United States Patent and Trademark Office

APPLICATION NO. FILING DATE FIRST NAMED INVENTOR ATTORNEY DOCKET NO. CONFIRMATION NO. 10/772,759 02/04/2004 Phillip L. Lam PERFECT-1/CIP 5694 1054 03/01/2006 **EXAMINER** 7590 LEONARD TACHNER, A PROFESSIONAL LAW MICHALSKI, SEAN M **CORPORATION** ART UNIT PAPER NUMBER 17961 SKY PARK CIRCLE, SUITE 38-E IRVINE, CA 92614 3725

DETAILED ACTION

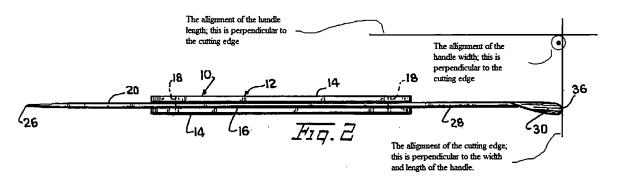
12. Regarding claim 8, Pesko further teaches that said elongated handle have a length exceeding its width (see figure 1) and having at least one end having a blade (36 figure 3), said blade having a cutting edge (38 figure 3) for removing cuticle skin (the blade is capable of removing cuticle skin, and was designed to cut said cuticle skin; column 3 lines 10-30). The Functional recitation that said blade be "for removing cuticle skin" has not been given patentable weight because it is in narrative form. In order to be given patentable weight, a functional recitation must be expressed as a "means" for performing the specified function, as set forth in 35 USC § 112, 6th paragraph, and must be supported by recitation in the claim of sufficient structure to warrant the presence of the functional language. *In re Fuller*, 1929 C.D. 172, 389 O.S. 279. Pesko further discloses that the blade edge is substantially perpendicular to said length and width of said handle (see figure below, the dot represents the handle width going into the plane of the page)

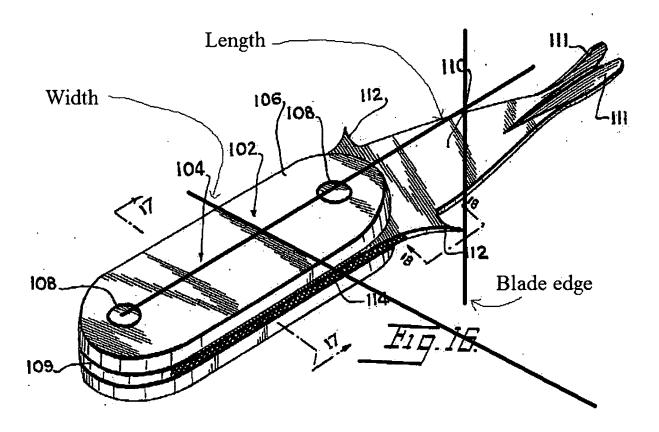
13. Regarding claim 9 (re-numbered from 10), Pesko discloses an elongated handle(10 figure 1) having a length exceeding it's width (as seen in figure 1) and having at least one end (106 figure 16) having a pair of spaced apart blade edges (the points of 112, figure 16), said blade edges being perpendicular to said handle width and length

(as shown in the figure below)

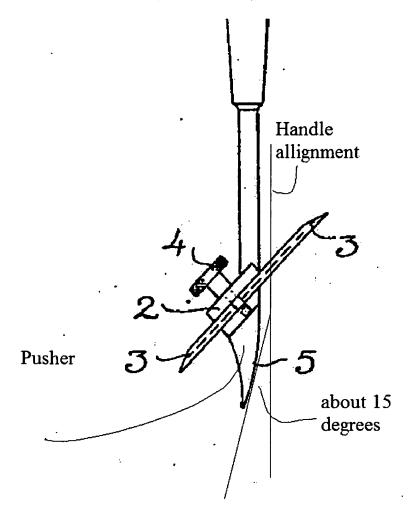
Regarding claim 16 Samiean further teaches that said pusher has an arcuate pushing edge (see figure 8, the center of the fin and each tip are all arcuate).
